HP L700/800 Printer Series

<u>Substrate advance system errors 0065-0002-0059 and 0065-0002-0061</u>

The purpose of this document is to provide an updated procedure for troubleshooting system errors that are specific to the media advance system.

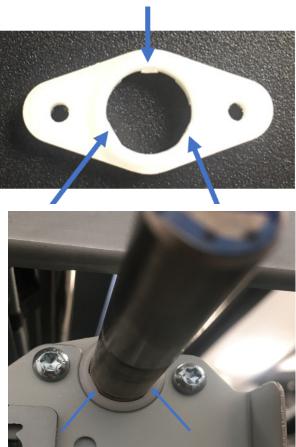
Verify that the Substrate Advance Motor gears are meshing correctly to ensure the
necessary accuracy during substrate advance movements. If there is a gap, as shown in
the left zoom image circled in red, the technician should remove and reinstall the Substrate
Advance Motor.

Ensure that the flat part of the shaft matches the flat area of the bushing, as shown in the pictures below.

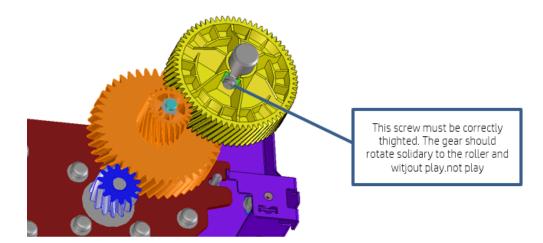
Verify that the screw holding the Drive Roller's gear to the roller is correctly tightened after any operation requiring the disassembly of the roller's cogs. If necessary, tighten the screw. The cog should rotate with the roller.

• It is essential to check the status of this screw, as a loose screw can cause severe transmission backlash and result in printer failure.
